Joint Development Authority
TCAAP Redevelopment Project

SUBJECT: Consider Recommendation of TRC Amendment Requests

RCC Proposed Amendments - TCAAP Redevelopment Code

Date: March 6, 2026
 To: John Mazzitello, Larina DeWalt – Ramsey County
 From: Eric Fosmo, Michael Kirsch – Kimley Horn

Proposed Vehicular Light Spacing (Per MnDOT Roadway Lighting Design Manual)

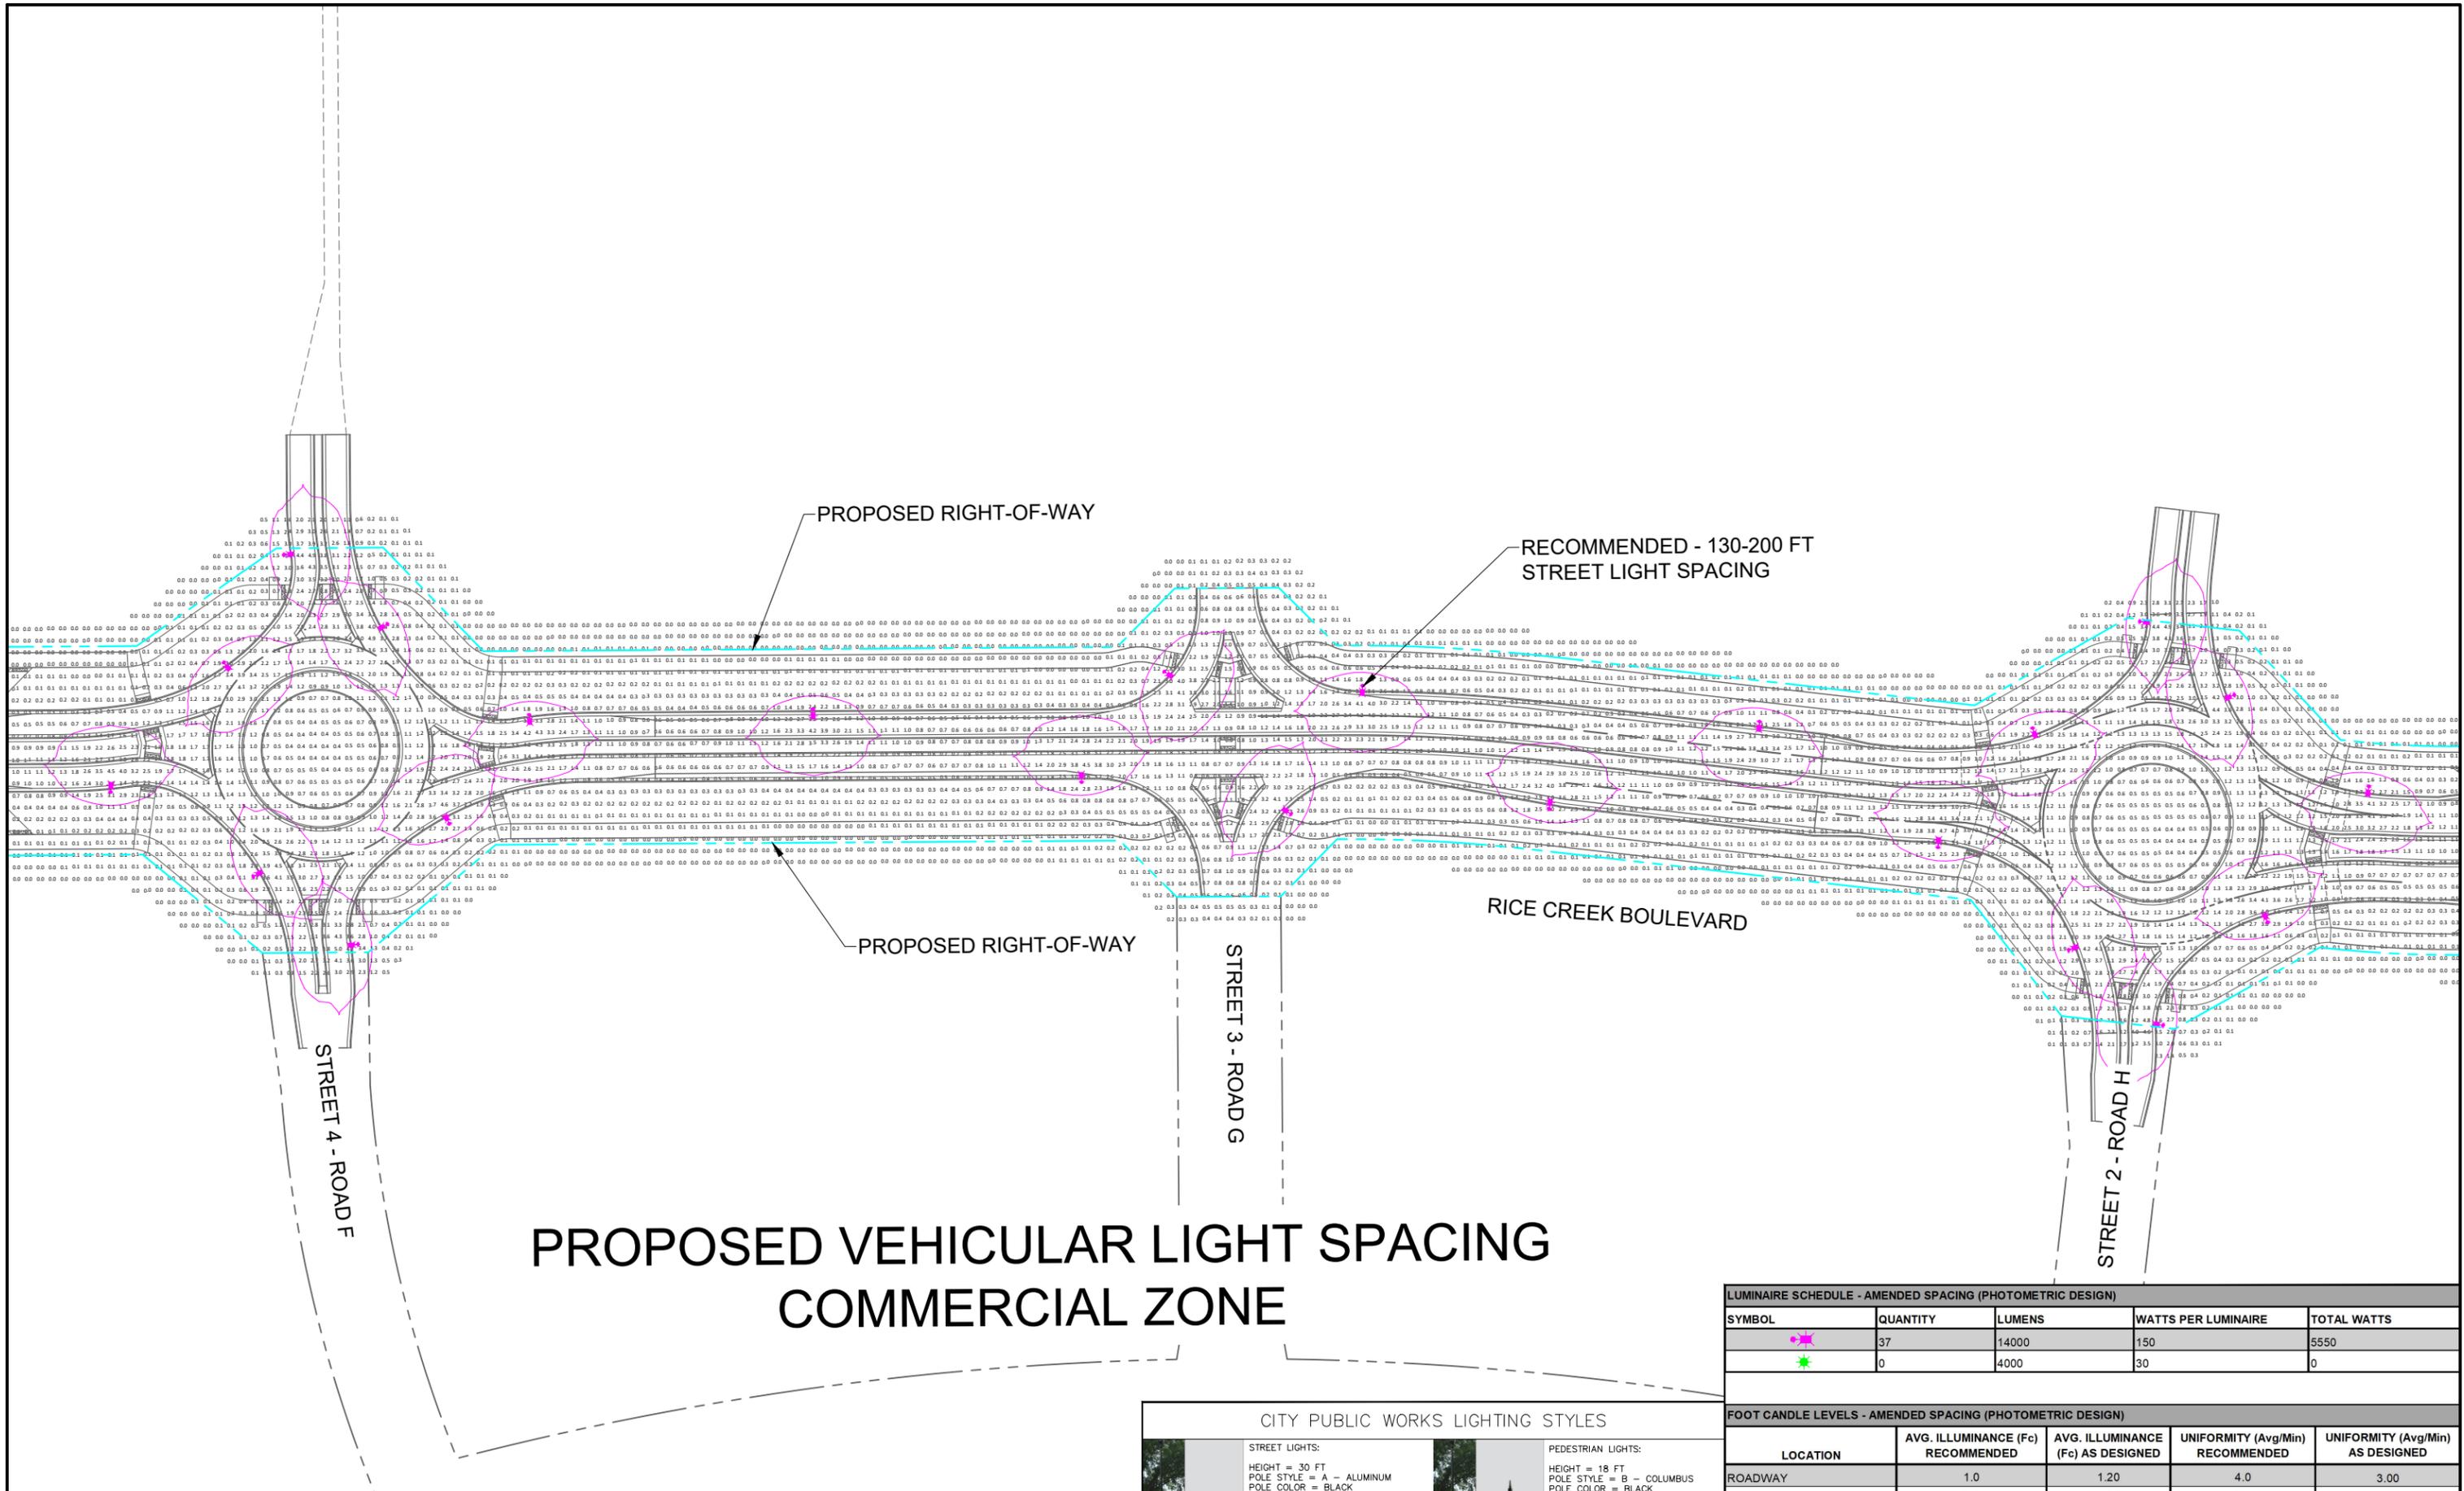
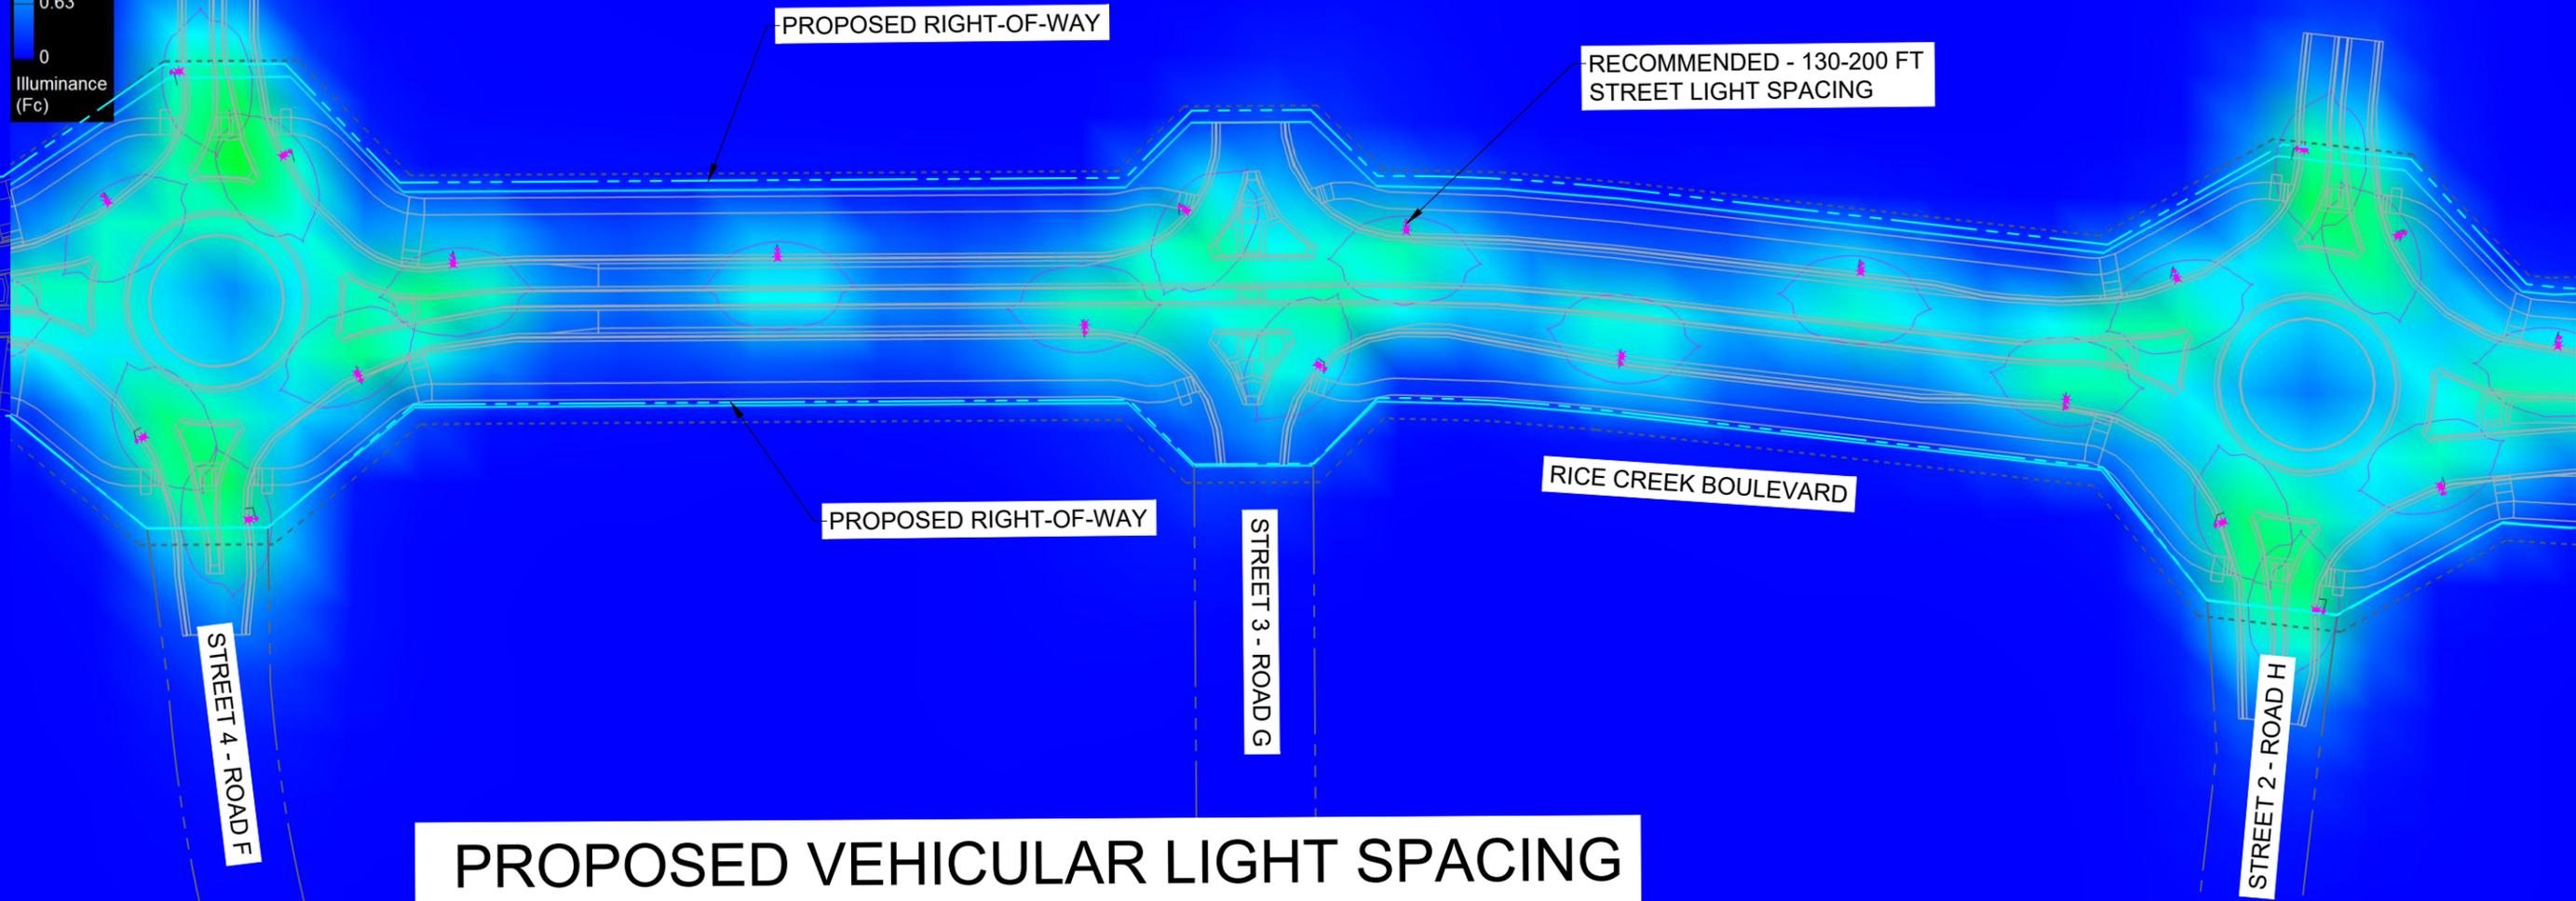
As written, the applicable code appears to allow for an approach where no lighting would be required along Rice Creek Boulevard. However, this approach would not be consistent with best safety practices nor City/County design precedence at the proposed roundabout intersections. The need to provide intersection lighting does not allow for compliance with the TRC through providing no lighting along Rice Creek Boulevard.

Roundabout Lighting: MnDOT and FHWA design guidance recommends that all roundabouts be lit to provide adequate visibility for all modes of transportation during non-daylight hours. This guidance is consistent with past precedence for roundabouts constructed by Ramsey County and the City of Arden Hills.
